ADDENDUM TO: VISTA-100 INSTALLATION INSTRUCTIONS

USE WITH ISSUE: N6019-2

The 5881EH wireless receiver and 5808 smoke detector are now listed for use in commercial fire applications. These features are pending CSFM approval. The following provisions apply:

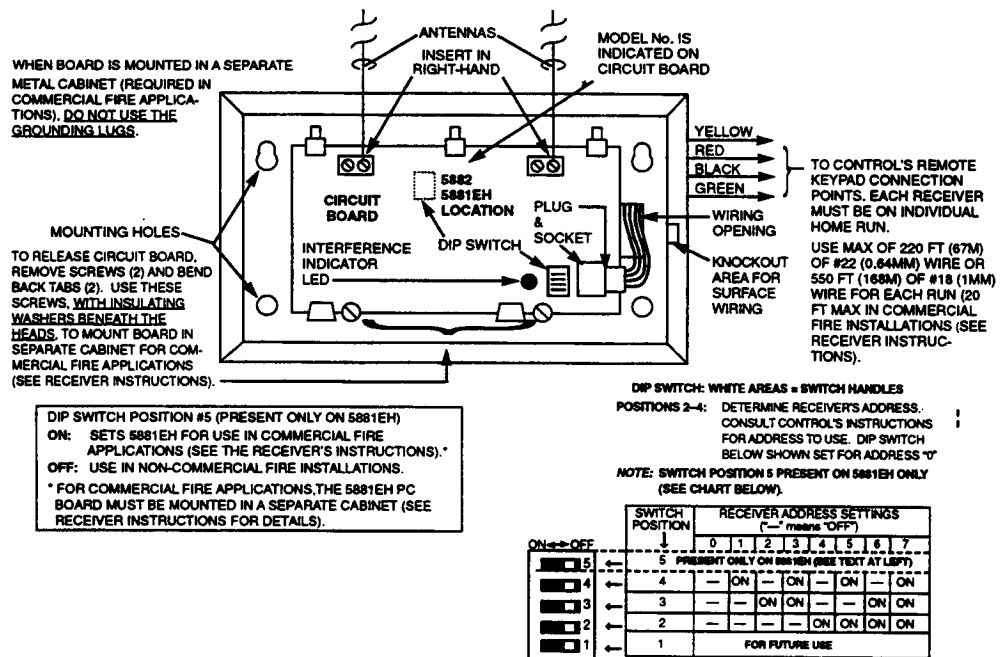
4. DIP Switch #5 on the 5881EH receiver must be set to "ON" for commercial fire applications (see figure below).
5. The 5881EH receiver must be mounted in a metal enclosure for commercial fire applications. When mounting in the enclosure, DO NOT use the antenna grounding lugs. Additionally, you must use an insulating washer (supplied) between the head of each screw and the PC board (see figure below).
